UNITED STATES PATENT AND TRADEMARK OFFICE

10/828,939

Office Action Summary

DETAILED ACTION

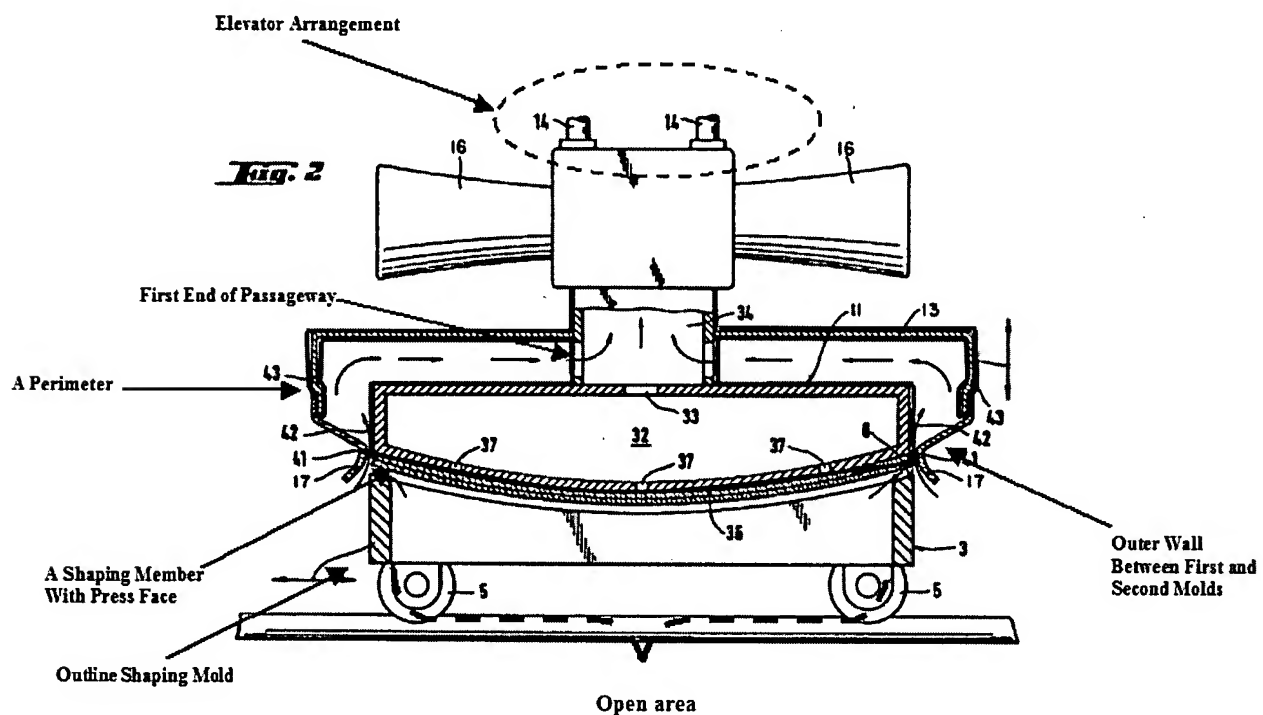
Claim 1, 2, 4-7, 12-18, 24- 29, 38, and 40 are rejected under 35 U.S.C. 102(b) as being anticipated by Kuster (US 5,713,976). Briefly, Kuster teaches a sheet bending apparatus comprising a concave annular bending block serving as both a bending ring and means for conveyance and a convex bending block acting from above on the surface of the glass sheet. With particular respect to claim 1, Applicant is directed to the annotated excerpt figure 2 below from the instant reference.

The Kuster apparatus presents a "major surface" of a first mold here indicated by a bold black line. This major surface defines the claimed features including the "perimeter" and the "shaping member" within and offset from said perimeter. The apparatus further provides "at least one passageway in the major surface" in a "non-shaping area" [**Claim 38**] which lies between the shaping member and the perimeter.

As clearly set forth in the prior office action, the Kuster reference teaches that the first mold is paired with a second mold or "outline shaping mold". The latter mold consists of spaced end rails and spaced central rails which collectively define a continuous, annular sheet supporting surface [**Claim 2**] and an "open area". An "outer wall" (17) is provided between the sheet supporting surface and the first end of the passageway, thereby forming a "boundary" with or between the sheet supporting surface and said passageway. An "elevator arrangement" (14) is provided to for relative movement of the first and second molds.

The outer wall described above is mounted to the major surface of the first mold [**Claim 4**], and in cooperation with the first and second molds, said outer wall defines an enclosure during a pressing operation (Column 4, lines 36-38). This outer wall surrounds and is spaced from the first end of the passageway and the shaping member

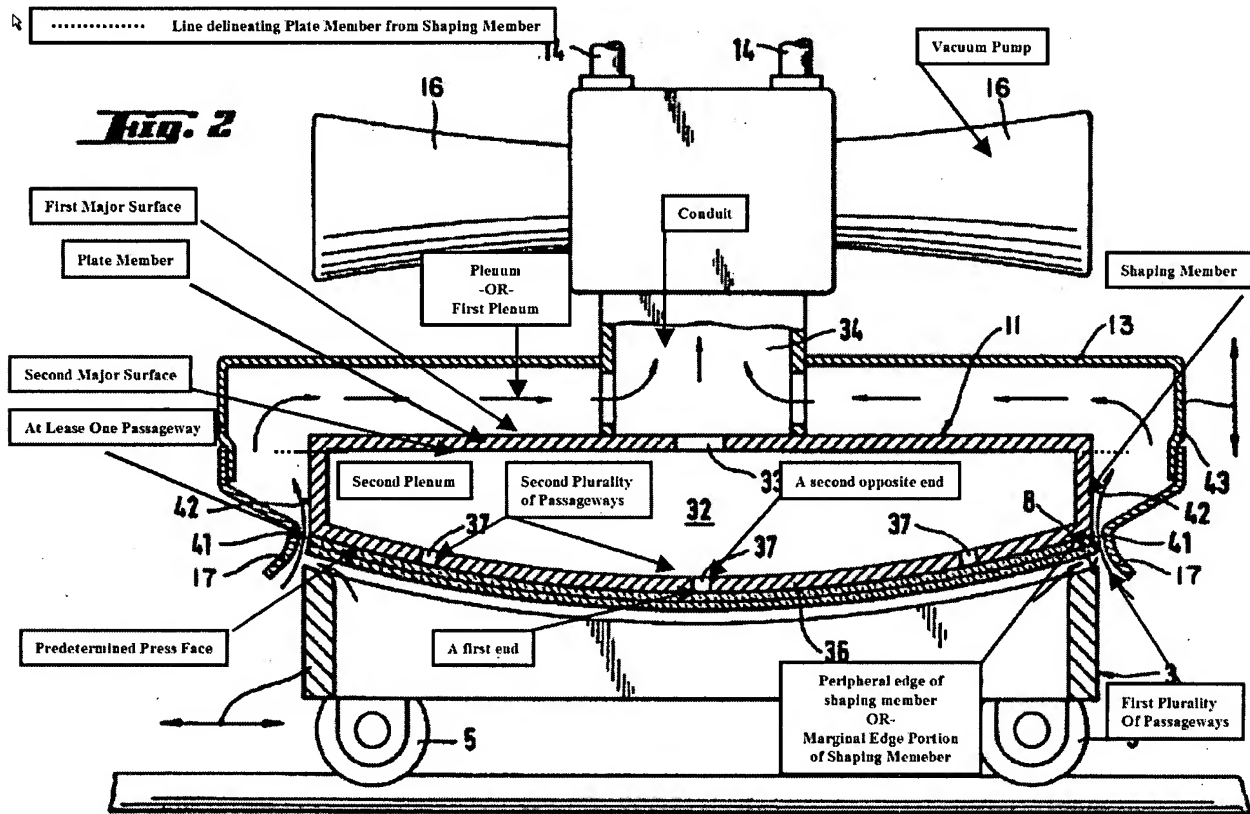
Regarding **Claim 12** and in light of the rejection of Claim 6 above, the rails in figure 2 above are understood to have an “I” shaped cross section with the upper end providing the sheet supporting surface. Further as outlined in the rejection of Claim 6,

the outer wall has one end "mounted" to the outer vertical surface of the "I" rail and extends away from the "I" rail and the open area during a press operation.

Claims 13, 14, 15, 16, 17, and 18 are anticipated in light of the second annotation of Figure 2 from the Kuster reference presented immediately above. Individual elements indicated on the first annotated version of Figure 2 have been re-annotated where appropriate to reflect applicant's chosen lexicon in the identified claims.

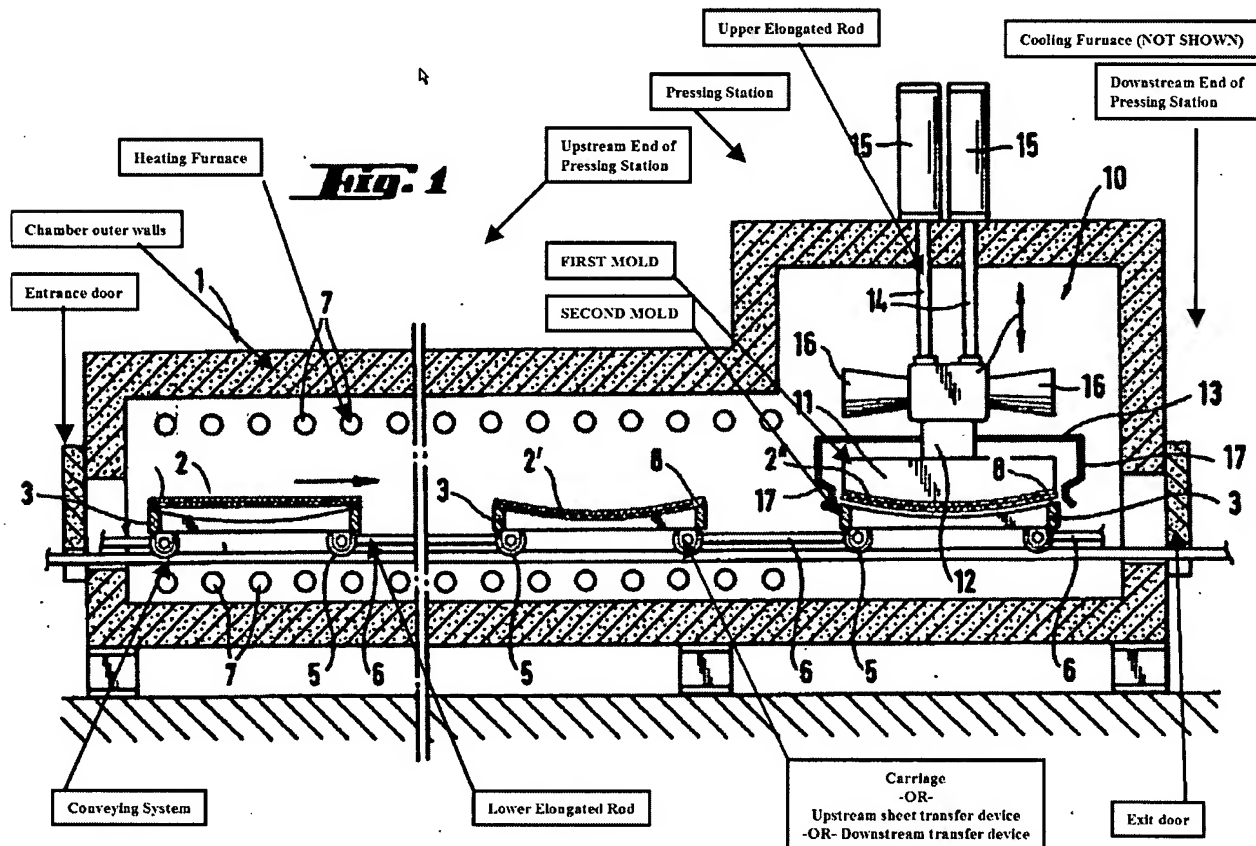
Claims 24, 25, 26, 27, and 28 are anticipated in light of the annotated excerpt figure 1 presented below. Said figure has been edited with examiners annotations in order to assist correlation of prior art teachings with applicants claimed elements in

applicants chosen lexicon. Details of the operation are also set forth in the immediate reference Column 3, line 56 through Column 4, line 49.

Claim 29 is anticipated in light of the combination of the annotated Figure 1 and the Figure 2 second annotation as presented above. Since the Fans (16) in figure 2 are in direct fluid communication with the open area of the second shaping mold through passageways (33) and (37), the Kuster apparatus is understood to be capable of moving air "through the open area of the second mold"

**FIG. 5**

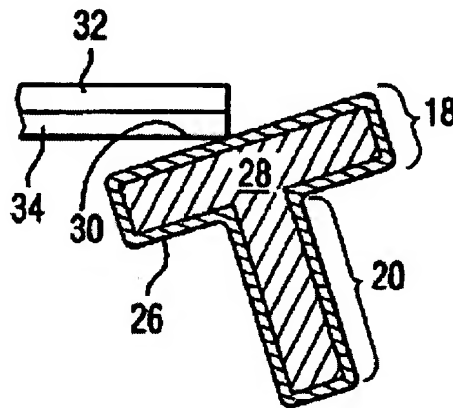
With respect to **Claim 8**, Kuster teaches that the central and end rails have a "I" shaped cross section (as evidenced in the Fig 2 excerpt above) while failing explicitly set forth that they may be constructed with a "T" shaped cross section as claimed. Skeen teaches (Column 2, Lines 3-6) that glass bending ring mold "rails themselves are usually pre-shaped to have a shape to support the unbent sheet while also supplying the mold for the curved or bent sheets" and that (see Fig 5 excerpt and Column 2, Lines 36-39) "the rail member itself may be a bar member that supports the glass sheets slightly inboard of the glass sheets periphery or it may be an "L" or "T" shaped member." It would have been obvious to one of ordinary skill in the art at the time of the invention to modify the central and end rails of the Kuster process to utilize a "T" shaped member as taught by Skeen. This would have been an obvious modification to one seeking to provide adequate support to both an unbent and bent glass sheet.

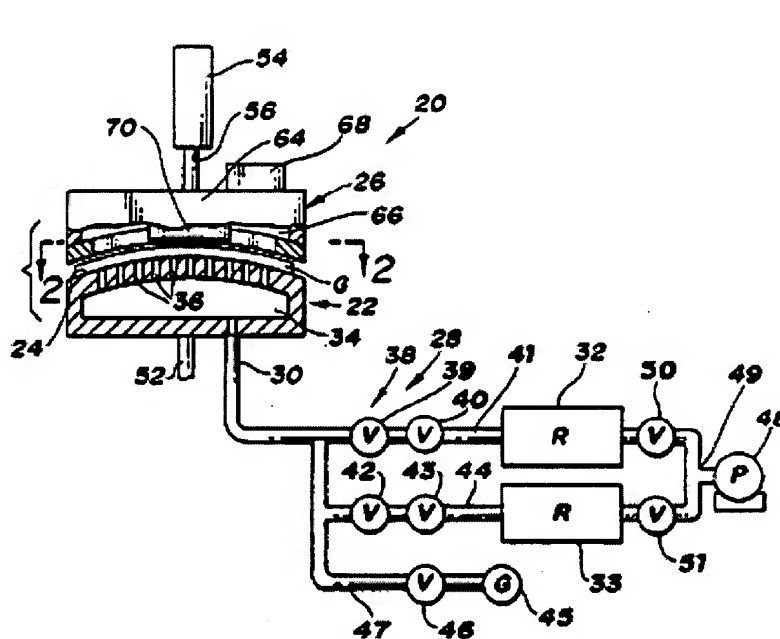
Regarding **Claim 9** and in light of the rejections of Claims 6 and 12 under 35 U.S.C. 102(b), Kuster teaches that the surrounding flange (17) portion of the outer wall can “eliminate the gap completely” by closing “the space between the annular bending ring (3) and the casing (13)” and as such is “connected” to the outer surface of the rail and extends away from said rail. In accord with the obviousness type modification set forth in the rejection of Claim 8 above and the premise set forth in Claims 6 and 12, it would be obvious to “connect” the surrounding flange (17) portion of the outer wall to the outer surface of the horizontal member of the “T” rail in order to “eliminate the gap completely” between the ring and the casing as taught by Kuster.

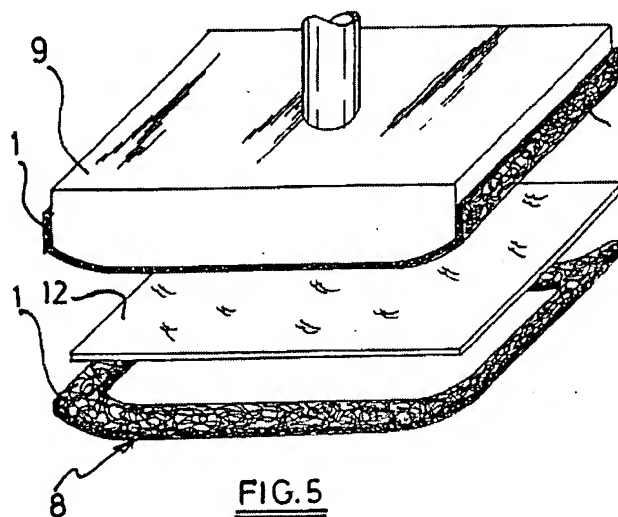
the second plenum should be connected via a valve having a first open position and a second open position. Shetterly, teaches a vacuum press mold utilizing a valve system (indicated as V in excerpt image below) to control application of vacuum or pressurized gas to the perforated pressing mold.

Further, Two-way valves of the type described by the applicant are old and well known tools in the art for switching a system between vacuum and pressure. It would have been obvious to one of ordinary skill in the art at the time of the invention to utilize a two-way valve or valve system as taught by Shetterly to control the application of "an excess pressure" in the second plenum as taught by Kuster. The use of a valve would have been obvious for one seeking selective application of either elevated pressure or vacuum to a system.

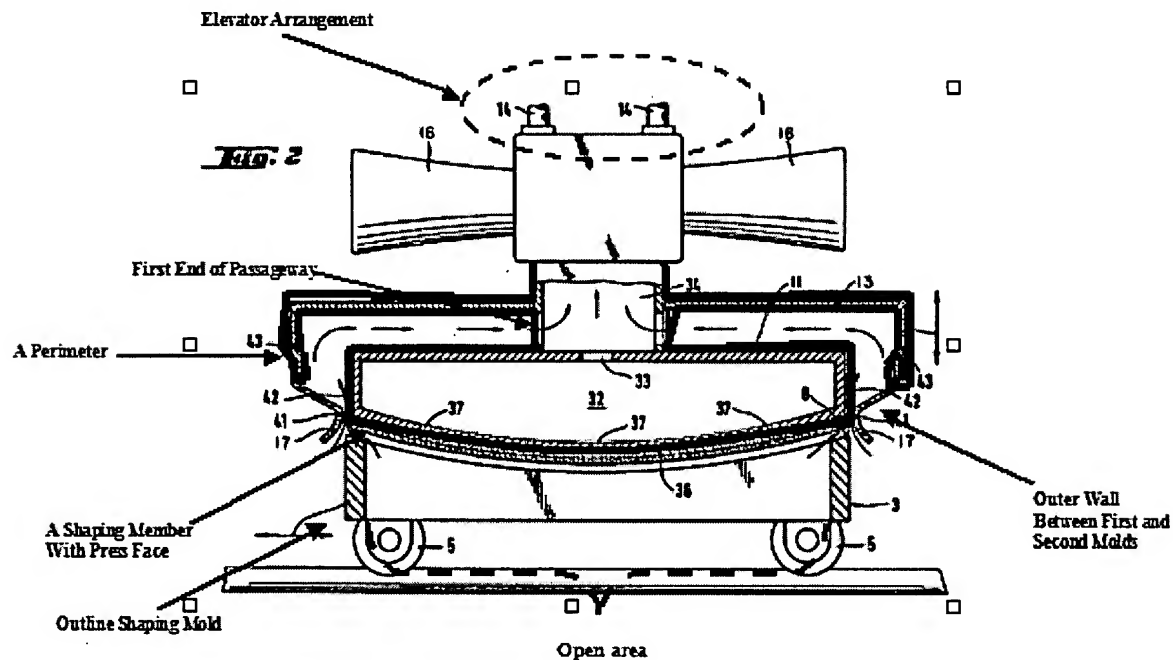
Applicant asserts that element (17) of Figure 2 in Kuster provides both the claimed "a major surface" and the claimed "outer wall" of claim 1. No such argument has been made by the Examiner in the previous Office Action dated march 07, 2007. The annotated Figure 2 excerpt from the prior Office Action has been reproduced below with an enhanced bold line reiterating the "major surface" as disclosed in the Kuster reference. As clearly depicted in the excerpt figure 2, Kuster provides a major surface delineated by the bold black line which presents a "perimeter" in the general region of element (43). A portion of the bold surface in the region of lead line (36) is clearly within and spaced from the perimeter in the region of element (43). The outer wall is a distinct element from but mounted to the "major surface" of the first mold. Since the record clearly indicates the distinct nature of the major surface and the outer wall as defined by the Kuster reference, Applicants arguments founded upon the unitary nature of these two elements is without merit.
